Service-Information Motorcycle

August 1991
34 025 91
(2467)

Brake Pipe Recall #91V-107 – R80RT, R100RT, R100RS

Installation Instructions:

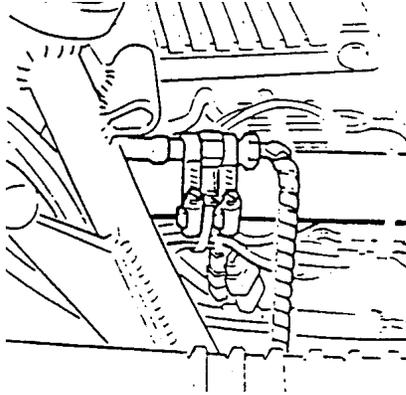
Problem: The brake pipe which is under the gas tank on the left side of the frame may chafe on the inside gas tank surface, or chafe on the speedometer cable.

1. Remove the fuel tank
2. Check whether the brake pipe touches the tank, speedometer cable or wiring harness. The brake pipe must be replaced if there are any scuff or chafing marks on it.

3. The brake pipe must be secured with an additional hose clamp and support, so that its position cannot change.

4. The protection sleeve is designed to shield the brake pipe. This protection sleeve can be installed on the brake hose either before or after the pipe is secured.
5. Ensure that there is sufficient clearance between the frame tube and brake pipe. If necessary, bend the pipe so that a distance of 14 mm is between the pipe and frame tube.

To make the assembly easier, remove the cable tie, which secures the wiring harness to the frame tube. Replace this cable tie after the brake pipe is in place and secured.

6. To prevent corrosion, any scuff marks on the fuel tank must be touched up. Our analysis of this chafing has proven that the fuel tank is only chafed a small amount. Therefore, it is not necessary to replace the fuel tank.
